Product Change Notification

PCN #: 6C-2022

DATE: 13th June 2022

- 453-00045

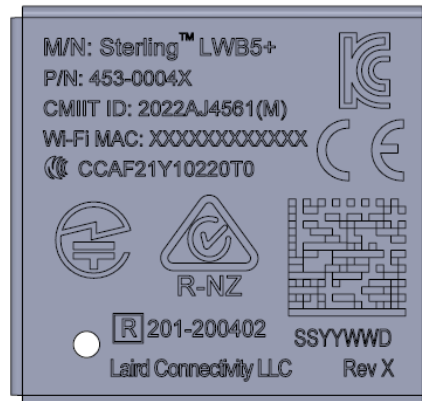
Part No.	Rev	Description
453-00045C/R	1	Certified with China SSRC, Taiwan NCC and Korea certificates
453-00045C/R 453-00046C/R 453-00047C/R	1	Certified with Korea KC certificate
453-00048 453-00049	1	Add KC ID/logo on 453-00047 RF shield

- Laser etching content change to include the certified regulatory logos and IDs
